Safety Evaluation With Open Items

U.S. EPR Design Certification

Chapter 7 – Instrumentation and Control Systems

**Figure 7.8-4 ATWS / D3 Mitigation Systems<sup>8</sup>**

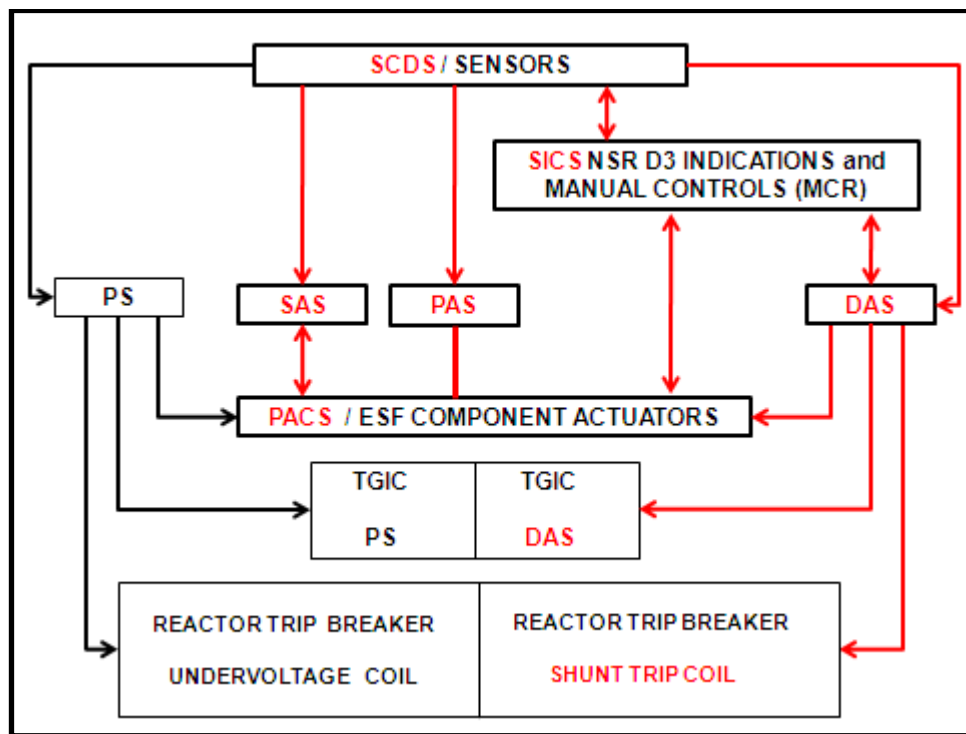
The top of Figure 07.08-4 of this report shows that the sensor inputs are common interconnections between the PS and the diverse PAS and DAS. The system credited to distribute sensor inputs to all three systems is the SCDS. FSAR Tier 2, Figure 7.1-23, Interim Revision 3 mark-Ups, provides a block representation of the SCDS system for one division.

At the bottom of Figure 07.08-4 of this report is displayed another interconnection between the PS and the diverse DAS at the reactor trip breakers. The staff evaluation of the adequate

Figure 7.8-5 Example of the PS ESF Actuation Signal Path for One Division

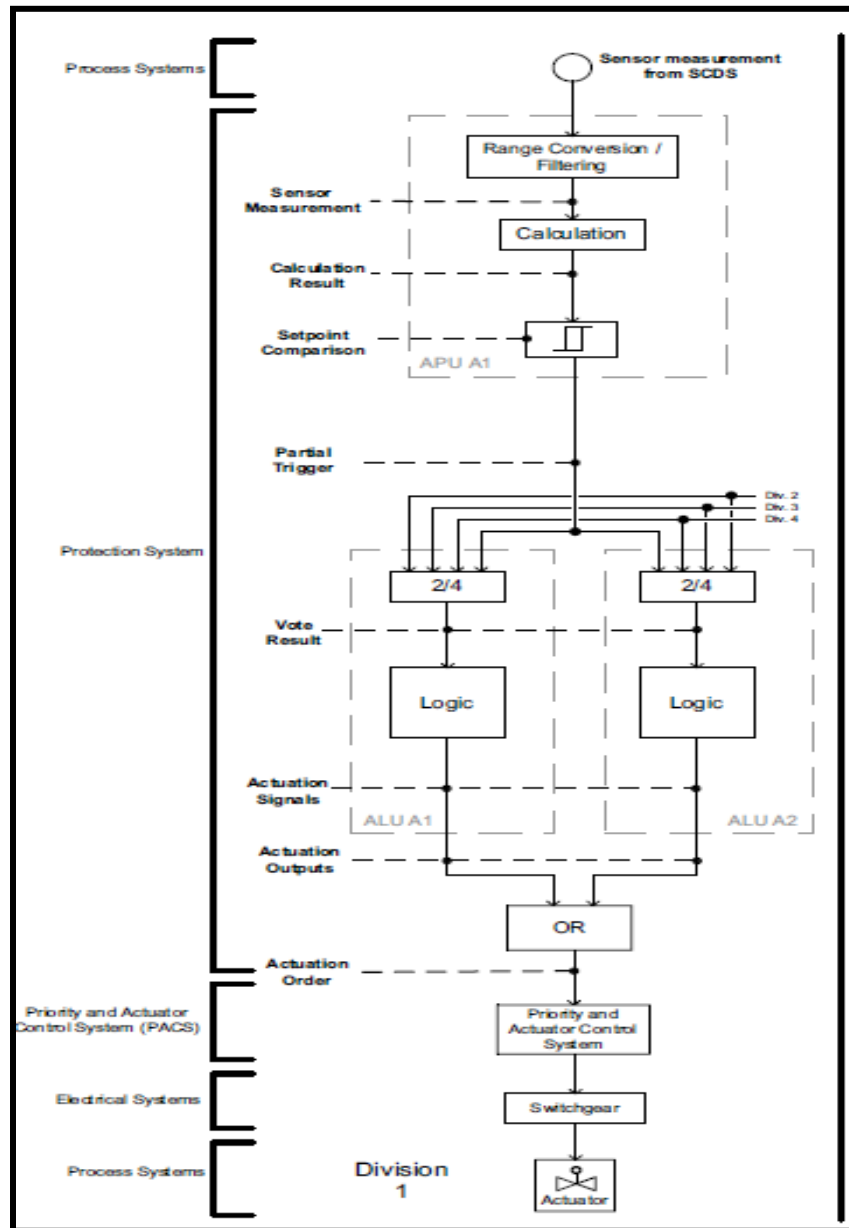
FSAR Tier 2, Figure 7.3-1, Interim Revision 3 mark-ups, provides a block diagram representation of an ESF actuation flowpath, from the sensor output to the final actuation device, for one division of the PS. The safety-related digital APU and ALU are TXS platform equipment. These TXS units consist of identical components (hardware and software) that are replicated across all PS safety division. Following the guidance of NUREG/CR-6303, for a postulated SCCF of one division's ALU(s), the failed ALU output signal could fail into a state requesting an ESF actuation. This credible failure is based on information listed in the failure modes and effect analysis results of Table A.3-1, "FMEA Results Table," located in Section A.3.2 of Technical Report ANP-10309, Revision 3. Therefore, replicating this SCCF across all PS divisions would send the faulted ALU ESF initiation signal to the PACS. The postulated CCF of the PS ALU's failed output signals to request ESF component actuation was not addressed in the D3 plant response assessment.

This particular SCCF scenario, where all PS divisions failed ALU output signals request ESF component actuation, would initiate ESF components and challenge the safety systems. However, the faulty ESF actuations would operate in the safe direction and would move to place the plant into a safe condition (i.e., SI system actuation injecting borated water into the core, closure of containment isolation valves).
